AMENDMENTS TO THE DRAWINGS

REMARKS

ADVISORY ACTION

Figure 12C

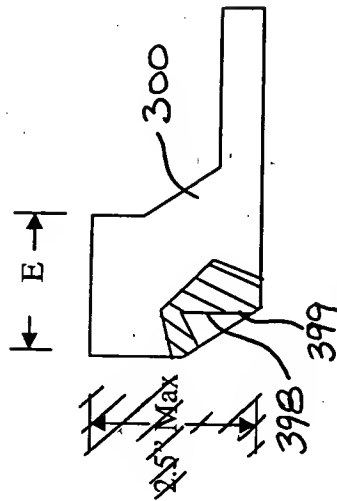
converted to formal drawings and specific dimensions have been deleted as follows. In figure 12A, the dimensions --3.0"-- and --2.0"-- and the dimension reference lines for these dimensions have been deleted. In figure 12B, the dimensions --4.0"-- and --3.0" MAX-- and the dimension reference lines for these dimensions have been deleted. In figure 12C, the dimension --2.5" MAX"-- and the dimension reference line for this dimension have been deleted. An Annotated Sheet 7/9 is provided for information and has been marked in red to show deletions made to the originally filed Sheet 7/9.
